EPA 542-R-13-006  
January 2013  
Office of Solid Waste and Emergency Response  
Office of Superfund Remediation and  
Technology Innovation

**Optimization Review**  
**Peck Iron and Metal Superfund Site**  
**Portsmouth, Virginia**

Report of the Optimization Review and  
Site Visit Conducted at the Peck Iron and Metal Superfund Site on  
February 22, 2012

January 18, 2013

**Figure 11**  
**Chromium Concentrations in Soils**  
**(0 to 18 inches bgs)**

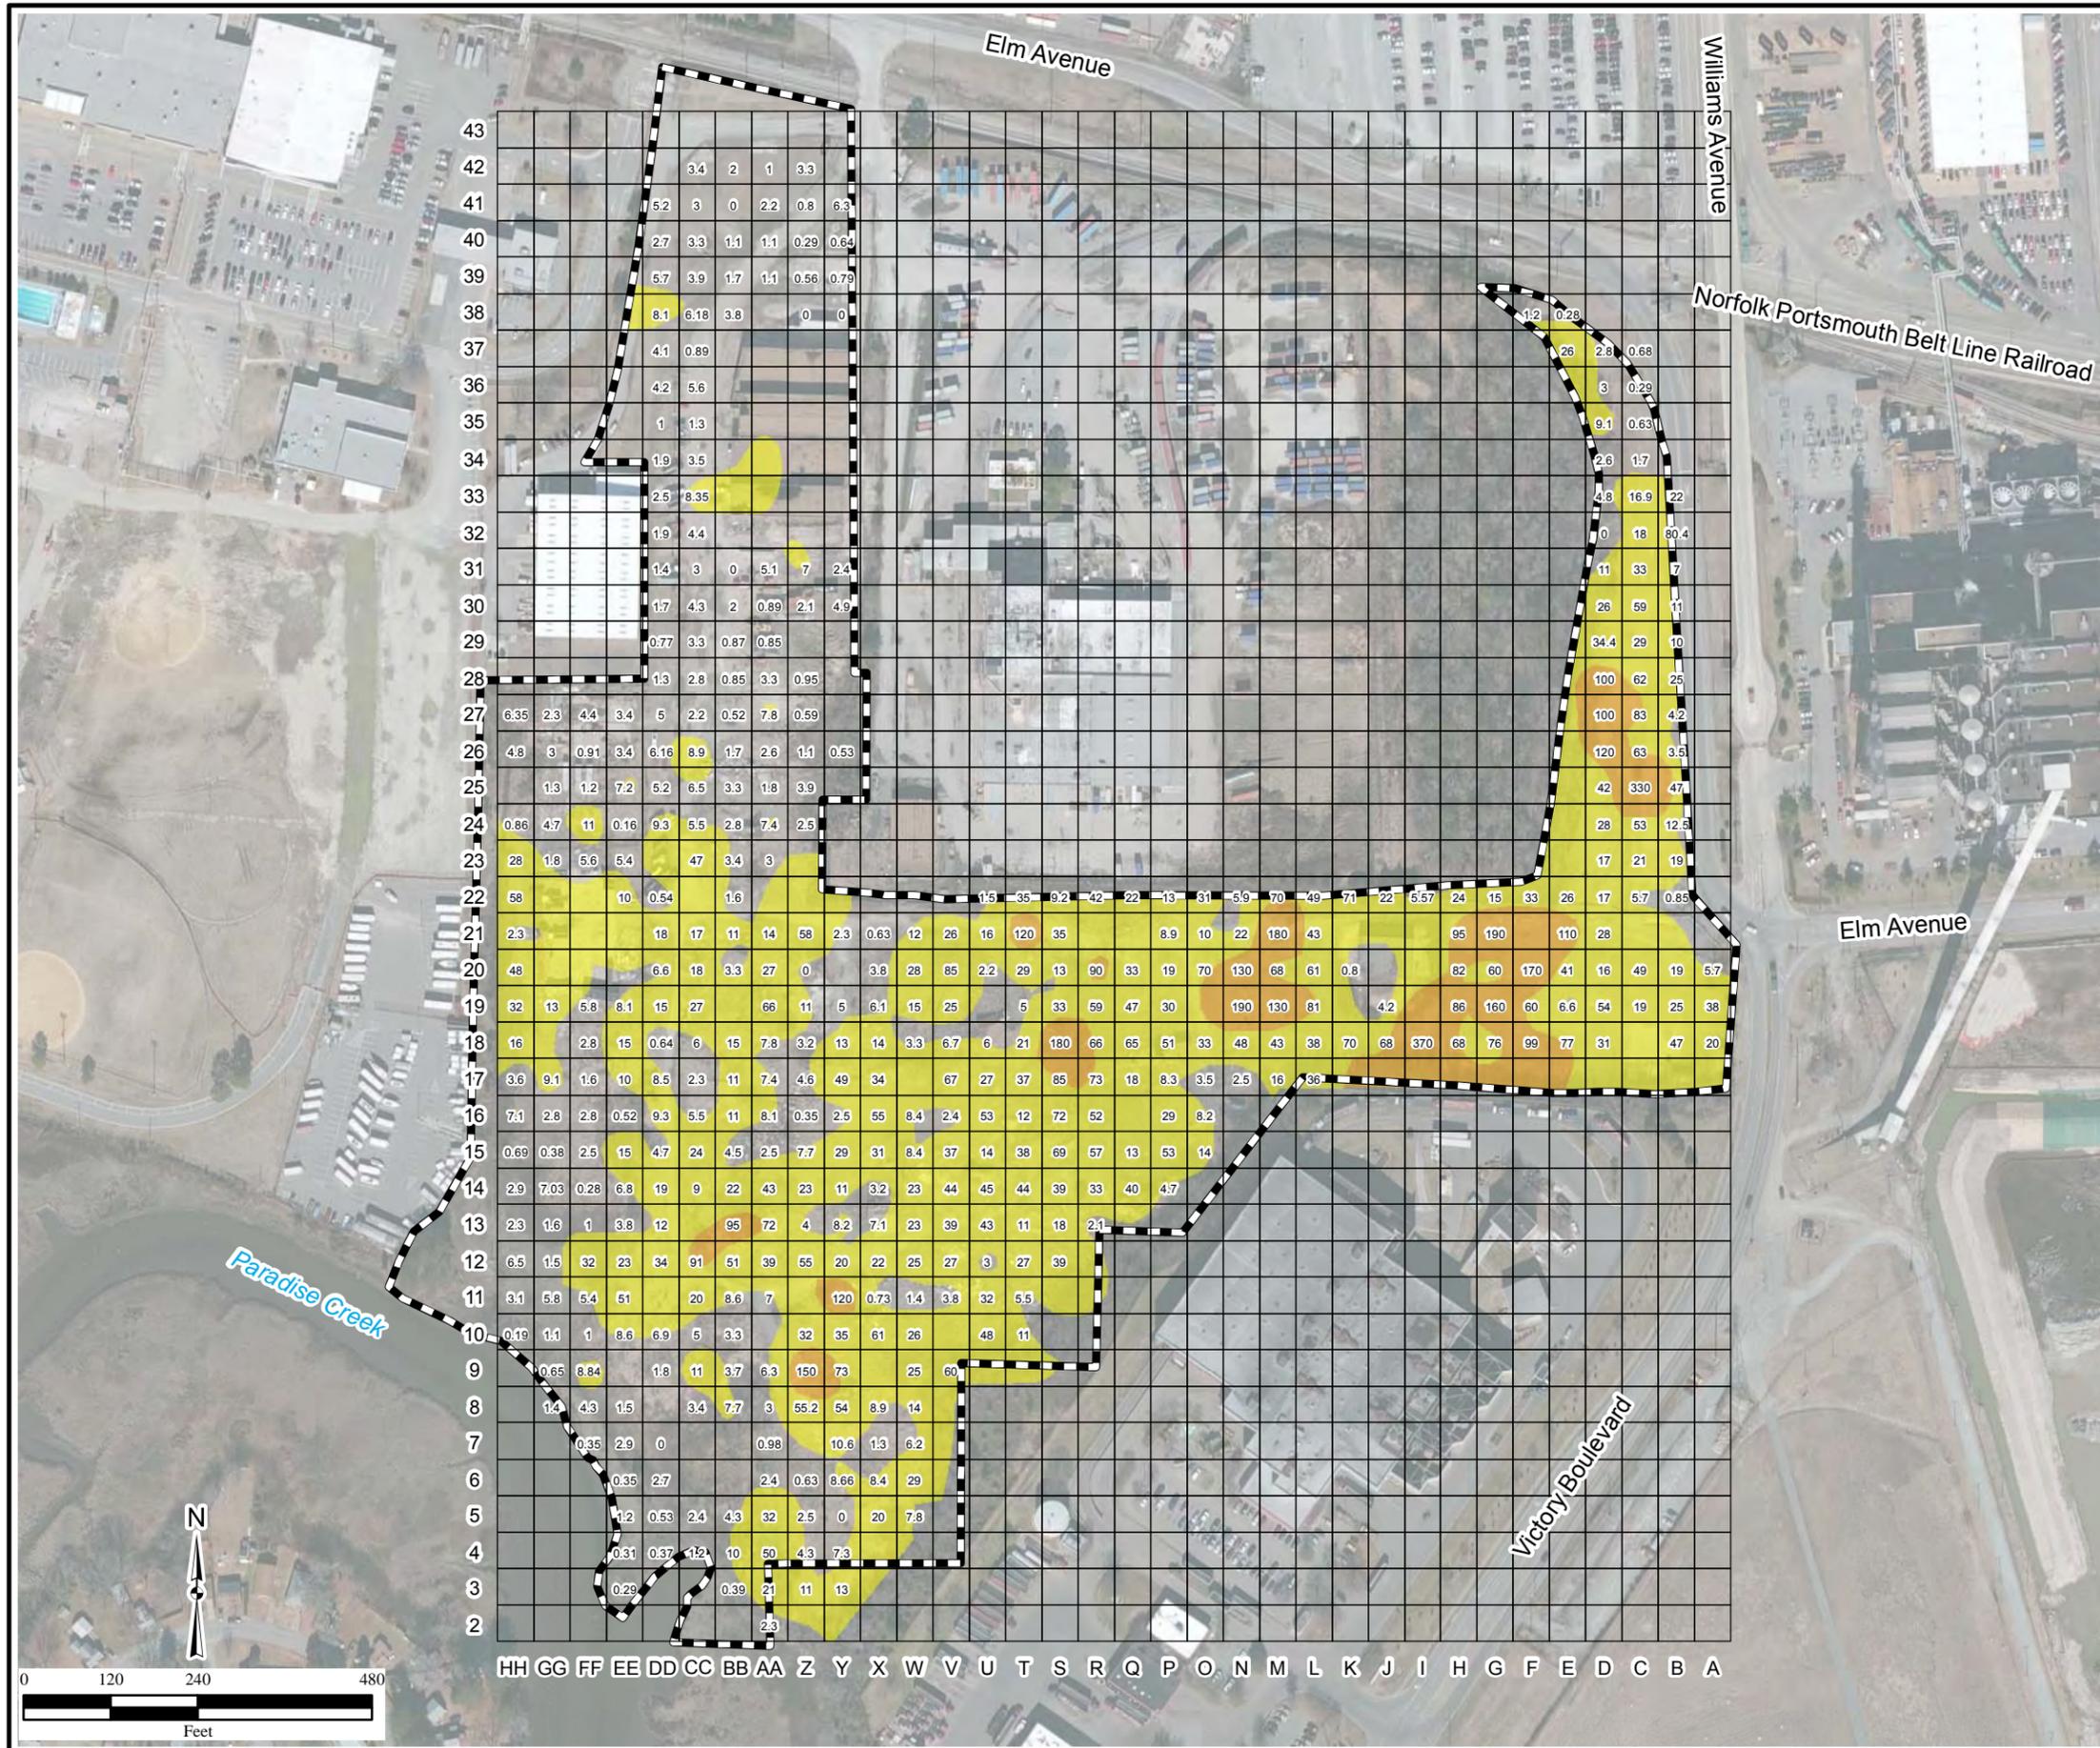
Total chromium exhibits elevated concentrations in soils across the Site (Figure 11) while cadmium concentrations are elevated Site-wide with the exception of the northwestern portion of the Site (Figure 10). Silver concentrations are generally below the residential RSL Site-wide (Figure 15). The total chromium hotspots (>20,000 mg/kg, the industrial soil RSL) are observed along the Site’s western boundary, one of which is in close proximity to the above-noted nickel hotspot. Cadmium exhibits hotspots (>80 mg/kg) in the central, eastern and northeastern portions of the Site.

Figure 11 shows chromium surface soil concentrations. Yellow, gold and red shaded grid cells indicate Site areas that exceed 56 mg/kg and thus define areas in which chromium concentrations exceed the screening level of 26 mg/kg. The remaining grid cells are all shaded green denoting chromium concentrations ranging from 5.6 to 56 mg/kg in surface soil. With the exception of single cell occurrences, green-shaded grid cells with posted concentrations less than the screening level are concentrated in the extreme northwestern portion of the Site (cells Y38-Y41, Z38-Z49 and AA39), the cells just south of the Sherwin Williams property (EE27 and FF27), cells in the southern wetland area (DD7, DD4, DD5, EE4, EE8) and cells in the extreme northeastern corner (C34-C37).

**Figure 12**  
**Lead Concentrations in Soils**  
**(0 to 18 inches bgs)**

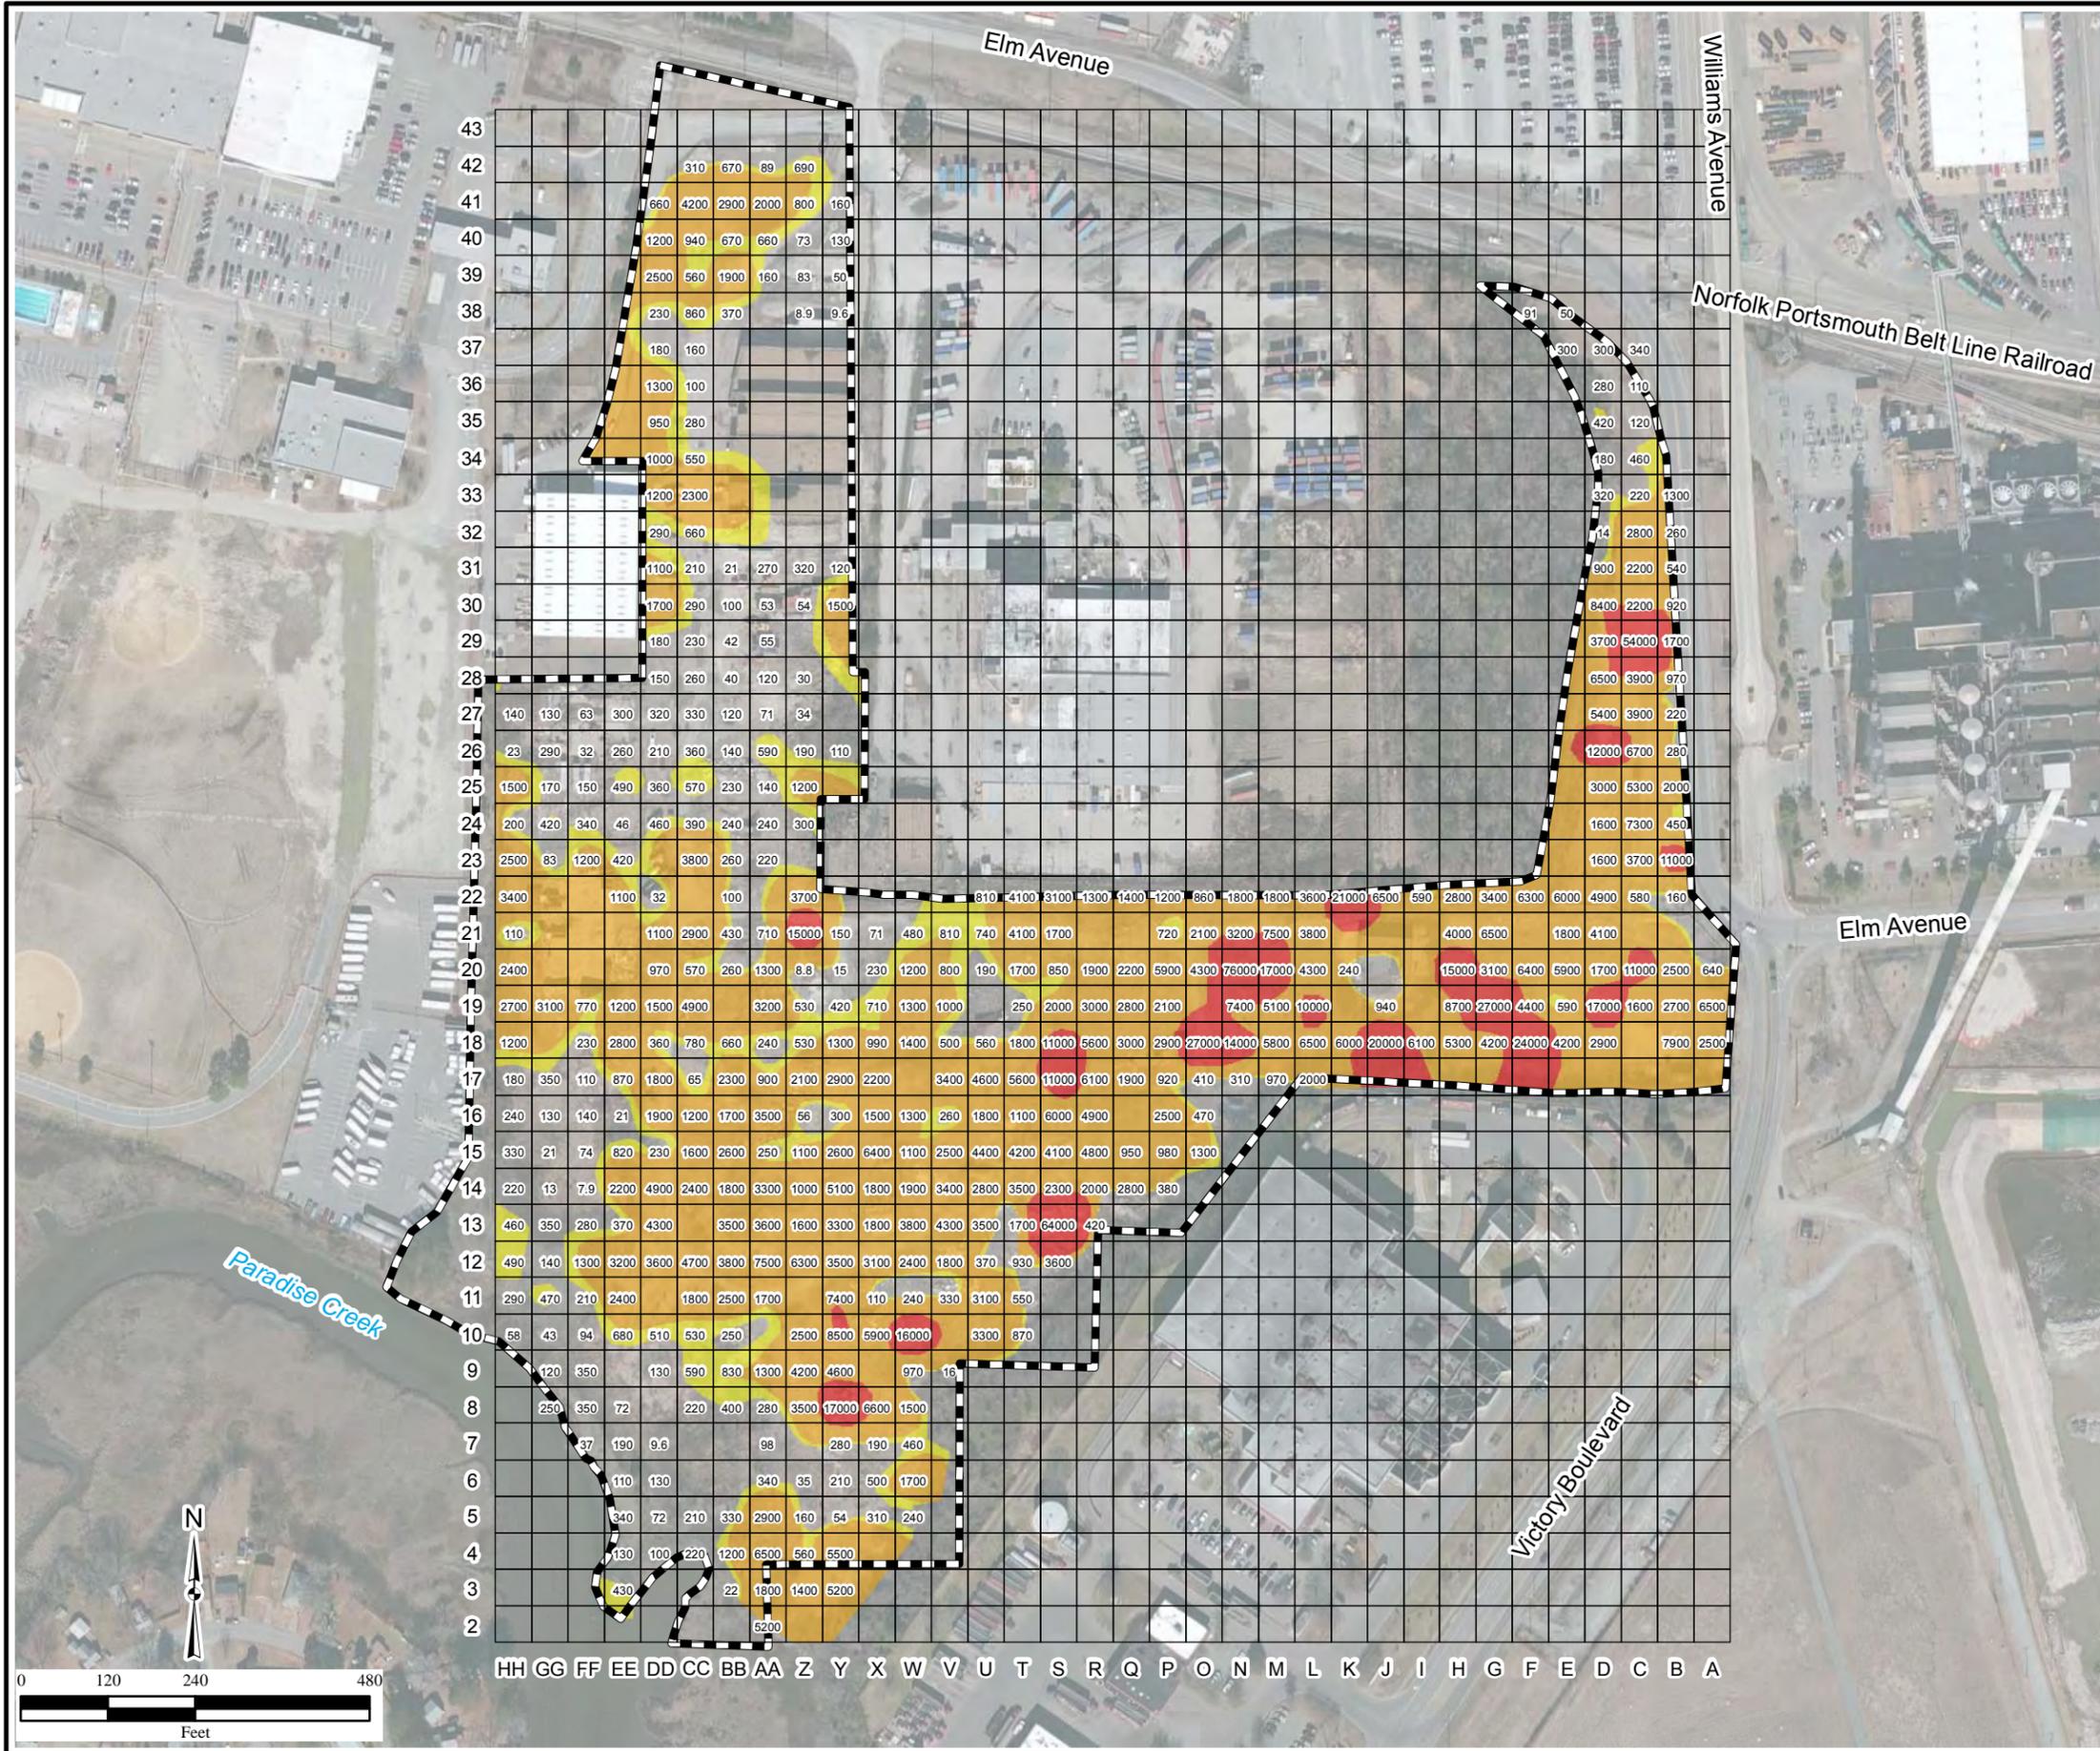
Figure 12 shows surface soil concentrations for lead. Because the minimum contour defines lead concentrations of 400 mg/kg or greater (compared to a screening level of 11 mg/kg), all shaded areas shown on the figure exceed the lead screening level. Review of the non-shaded areas (lead concentrations below 400 mg/kg) reveals that with only a small number of exceptions, all non-shaded grid blocks also exceed the lead screening level. Contiguous cells with posted concentrations less than the screening level include cells Y38-Y39 in the northwestern portion of the Site.
